Request For Information - 036

The Cora Apartments (19 W Harrison)

Subject:	**Party Wall Assembly Clarification at Shower Stalls**	**Status:**	**Open**
Drawing #: A203, A204, A205, A206, A207.		**Spec Sect #:**	
Addendum:		**Submittal #:**

ADA Shower Transfer Clearance Box diagram-

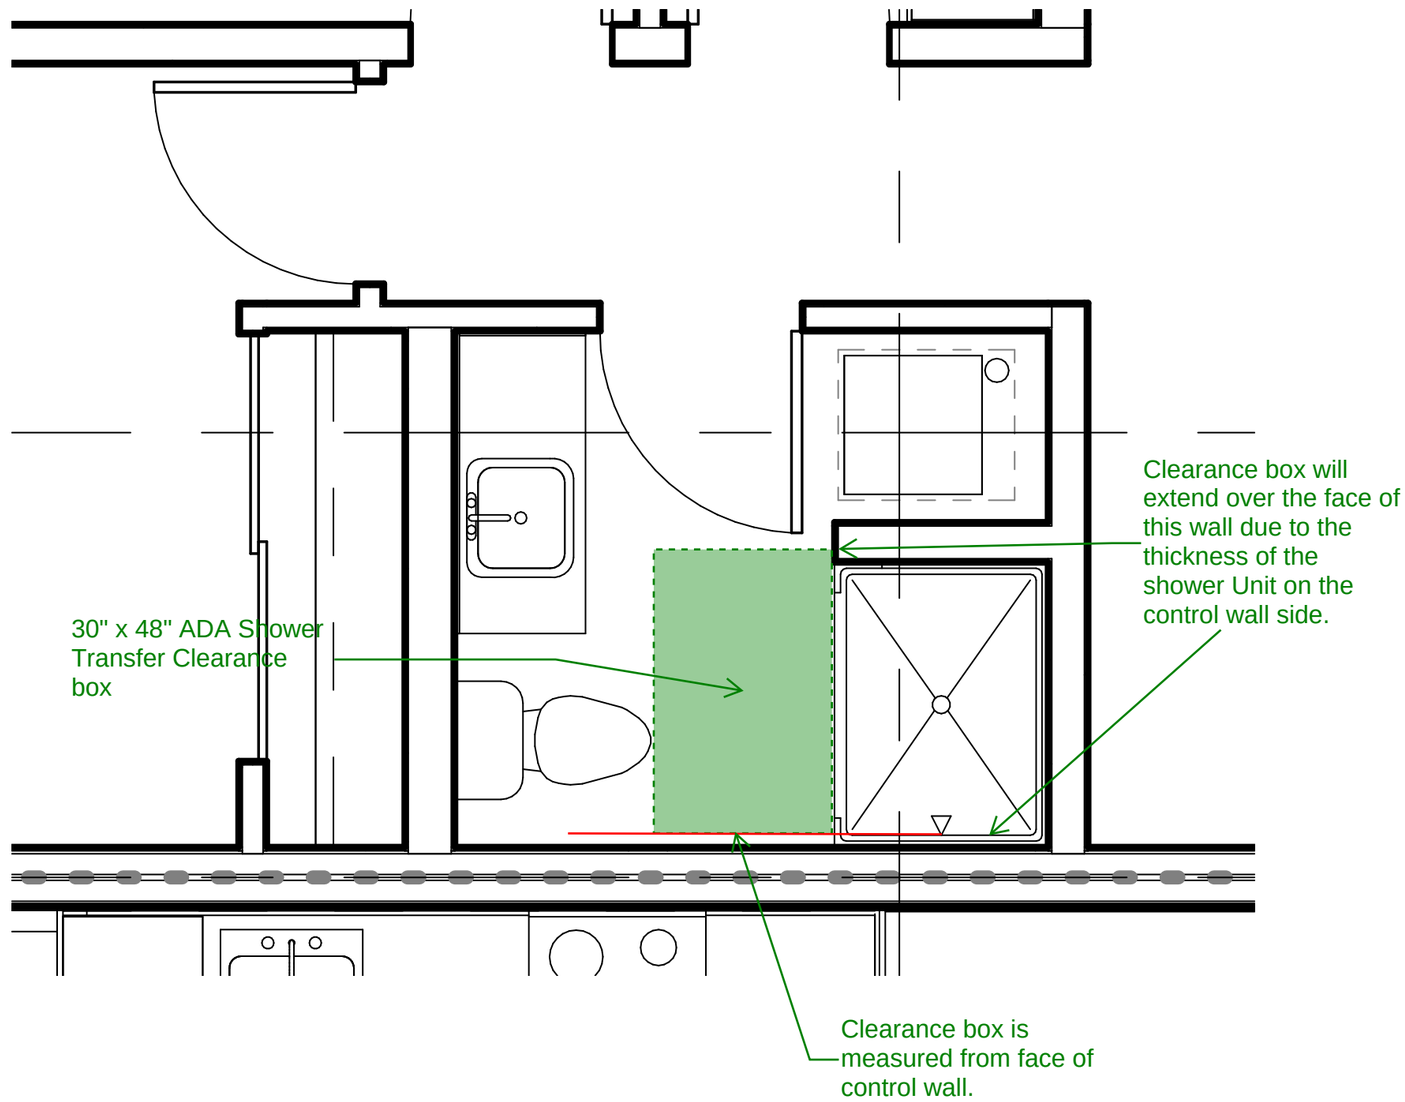
The shower stall controls valves and showerheads in unit stacks x02, x06, x10 and x12 (except for unit 302) are located on the party walls, as shown on the attached partial floor plans. Please verify if this is correct. If not, please provide wall details for those locations.

Date	Response
8-26-2016	Yes, the Shower Head control wall must be on the demising wall side in order for the 30" x 48" ADA Shower Transfer Clearance box to work within the bathroom space. -See attached diagram- Exxel will need to provide shower controls that at UL listed for a 1 hour rated wall and provide acoustical insulation around valve box within the Demising wall. JXW
